November 4, 2022

**Re: Response to Comments from Scoping Document 1 for the Proposed Surrender and Decommissioning of the Newhalem Creek Hydroelectric Project (P-2705-037)**

Figure 1. LiDAR hill shade image showing interpreted relationship between smaller, active debris slide area relative to older, larger debris slide area.

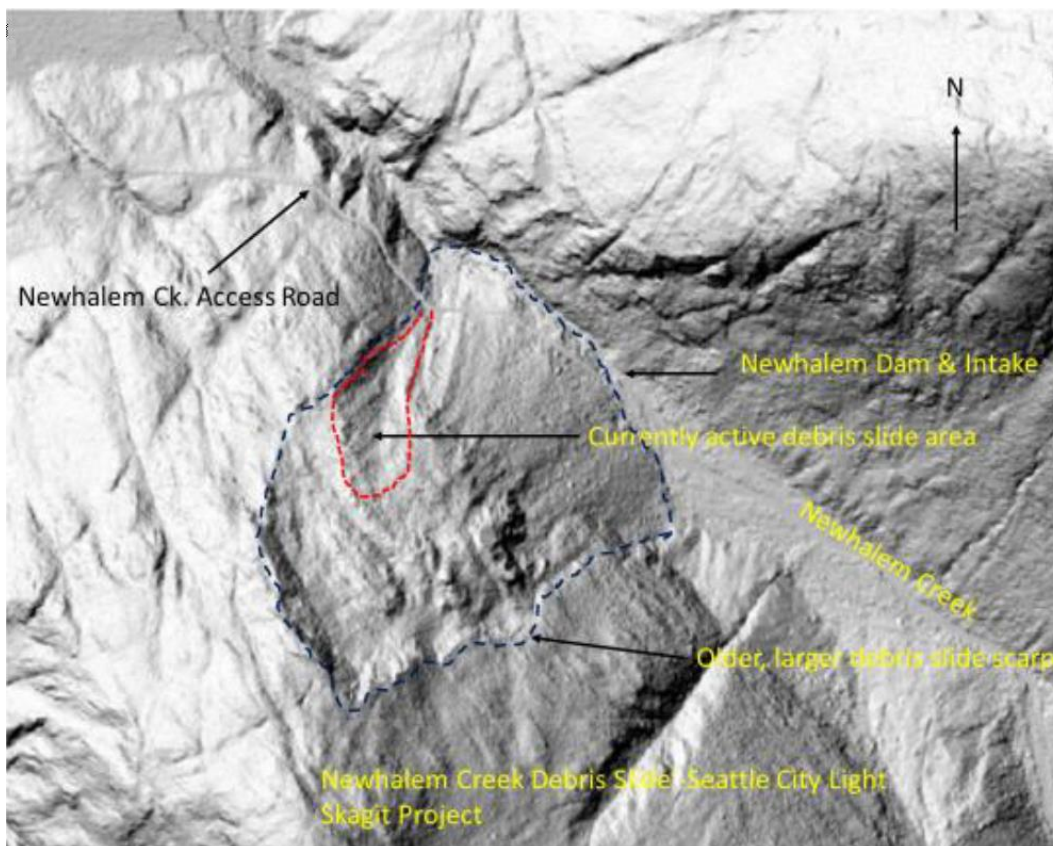
- **The short-term and long-term effects of rock scaling and road decommissioning on slope stability associated with hill slope failure and access road at 10U 628747 E, 5391257 N. As part of this assessment, we recommend that a photogrammetric survey of the slide area and surroundings that clearly defines the extent of the unstable area be conducted. We also request that the survey occur before and after the completion of the decommission to assess the effects of the road, decommissioning actions including rock scaling, and any mitigations that may be employed.**
- **The short-term and long-term effects of sediment transport and deposition in Newhalem Creek associated with hill slope failure, rock scaling, and access road at 10U 628747 E, 5391257 N.**

Failing road conditions are due to slope instability and the original method of road construction. The road crosses through an active landslide, which is part of a much larger, older landslide, and is also positioned upon the older landslide's accumulation zone (see Figure 1 below). Aside from the unstable slope, roadway failure stems from faulty historical construction methods that involved cutting into the upslope side and casting fill on the downslope side without compaction or grading of the roadway surface to produce a more stable slope angle (e.g., 2H:1V), resulting in tension cracks.<sup>3</sup>

Rock scaling as part of the proposed decommissioning project would only target loose rocks with potential to fall during construction. These rocks are likely to fall in the near term regardless of City Light's intervention; thus, scaling would not result in changes to the landscape or effects to Newhalem Creek that would not otherwise naturally occur. The slope will continue to erode regardless of proposed decommissioning activities due to rain exposure on an over-steepened slope and surface water flowing along the head and lateral scarps, which has likely increased due to the 2015 wildfire that burned most trees in the area. The unraveling slope has already affected Newhalem Creek when the mass associated with the larger landslide filled Newhalem Creek for approximately 2,000 linear feet, shifting the creek to the north as a result. The larger landslide may be activated again as Newhalem Creek erodes the toe of the mass (Figure 1).<sup>3</sup>

Proposed road decommissioning activities would not worsen road or slope stability, nor create any additional factors that would affect slope stability. In fact, road decommissioning work includes measures that normally improve slope stability under different geological circumstances. Road decommissioning work includes removing the culverts and reshaping the small, ephemeral, and intermittent drainages to re-establish flow. Then, a "rough and loose" restoration technique would be applied to the compacted roadway surface by scooping soil approximately 2 feet deep with an

*Figure 2. View of the waterfall from the edge of the road at the best vantage point.*

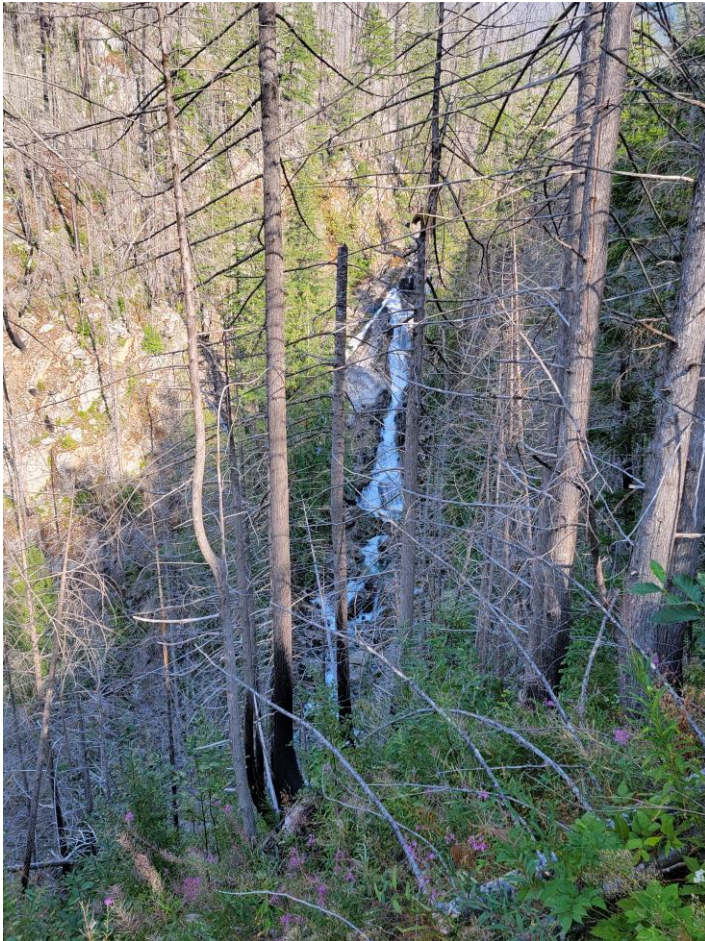
- **The effects related to the loss of recreational access to view Newhalem Falls and Newhalem Creek above the falls.**

From the road providing access to the dam, limited partial views of the waterfall are available. Before the 2015 wildfire, the waterfall was only visible through narrow slits between the trees from vantages along the cliff edge adjacent to the roadway. Since the wildfire, the topmost portion of the waterfall is visible through the dead trees (Figure 2). The waterfall is not a prominent feature along the roadway. Once forested vegetation recovers from the fire, most of the view will be blocked again.
